In re: K287AK, Lebanon, OR  
BPFT-20161031AAS  
Facility ID No. 148055

This letter refers to the above-captioned translator application for K287AK, Lebanon, Oregon.

K287AK

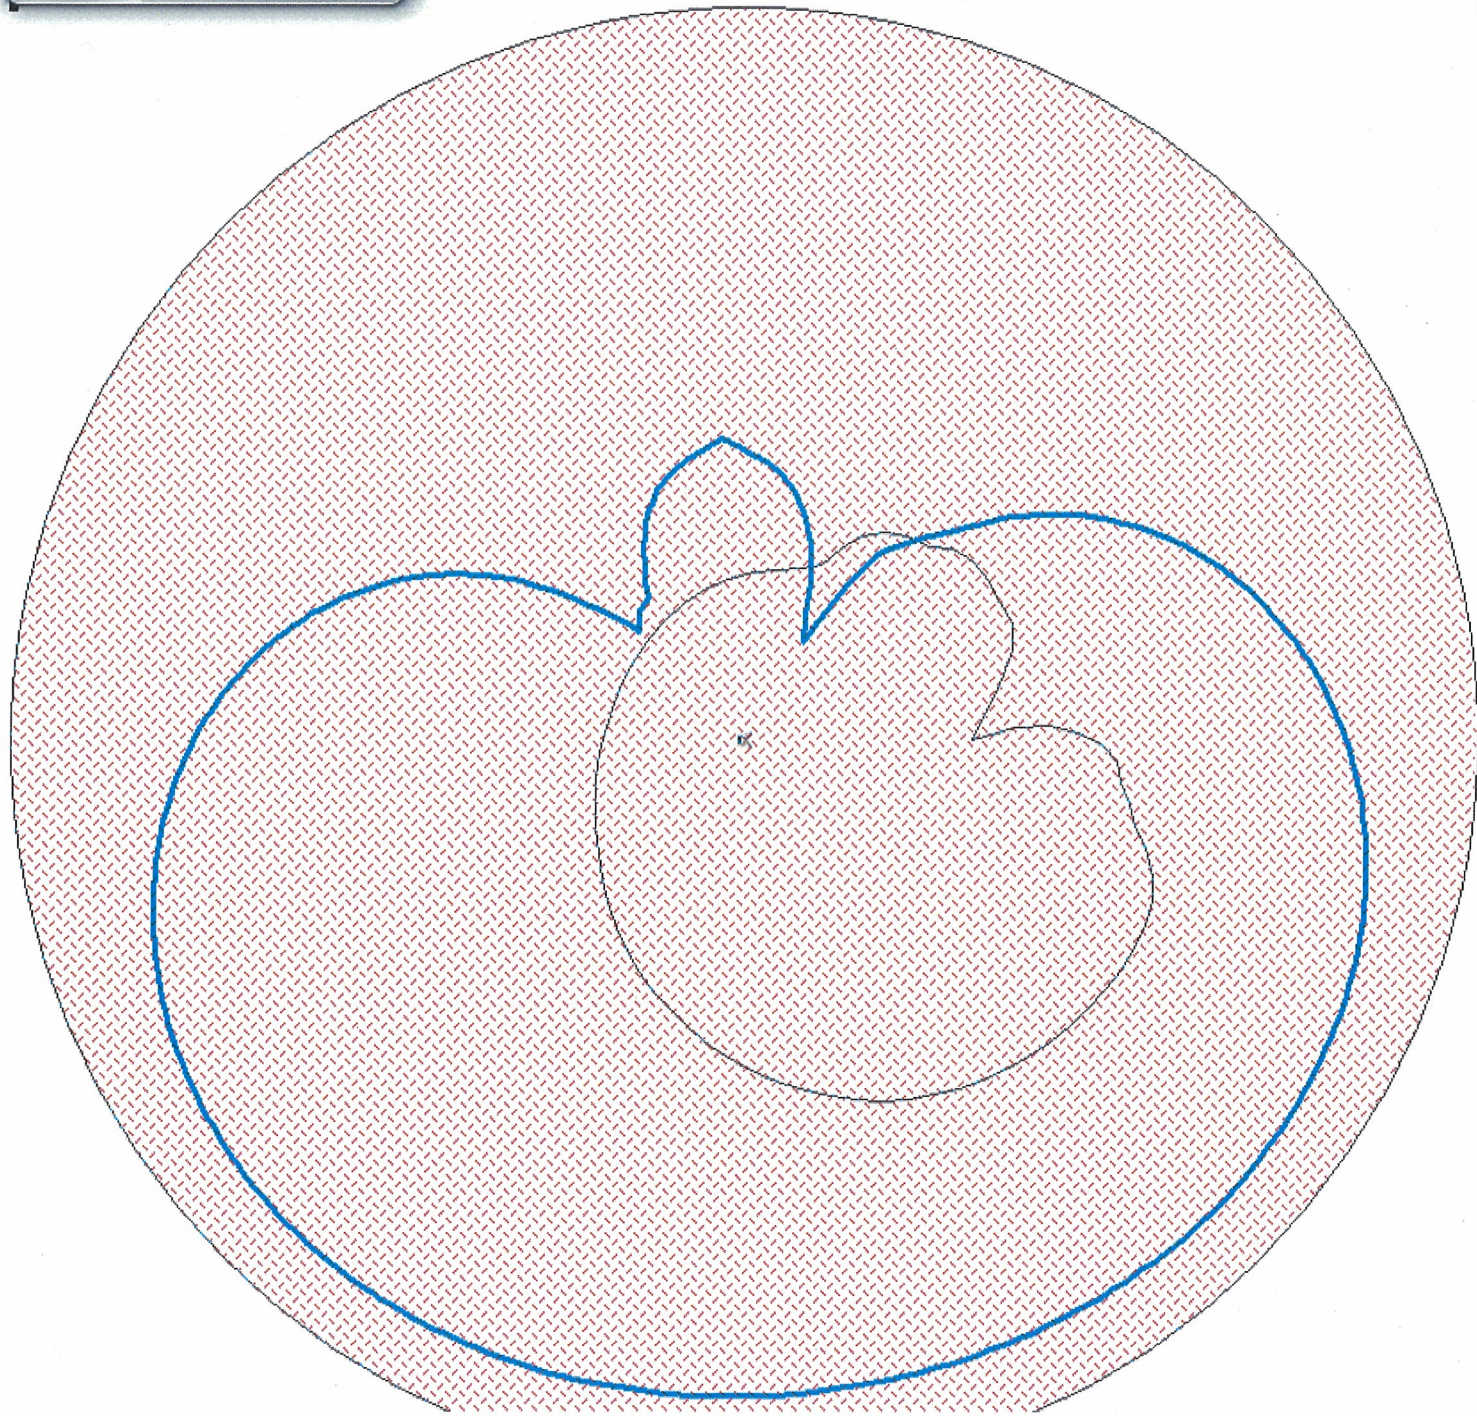
Our study of the application reveals that it is in violation of Section 74.1201(g) of the Commission's Rules. Section 74.1201(g) states that the coverage contour of an FM translator rebroadcasting an AM radio broadcast station as its primary station must be contained within the lesser of the 2 mV/m daytime contour of the AM station and a 25-mile (40 km) radius centered at the AM transmitter site. The proposed coverage contour (60 dBμ) of the translator is not contained within the lesser of the 2 mV/m daytime contour of KSHO(AM), and a 25-mile (40 km) radius centered at KSHO's transmitter site. Therefore, the application will be dismissed.

In light of the above, the application BPFT-20161031AAS filed by Sunriver Broadcasting Corporation, is unacceptable for filing pursuant to 47 C.F.R. § 73.3566(a) and IS HEREBY DISMISSED. This action is taken pursuant to 47 C.F.R. § 0.283.
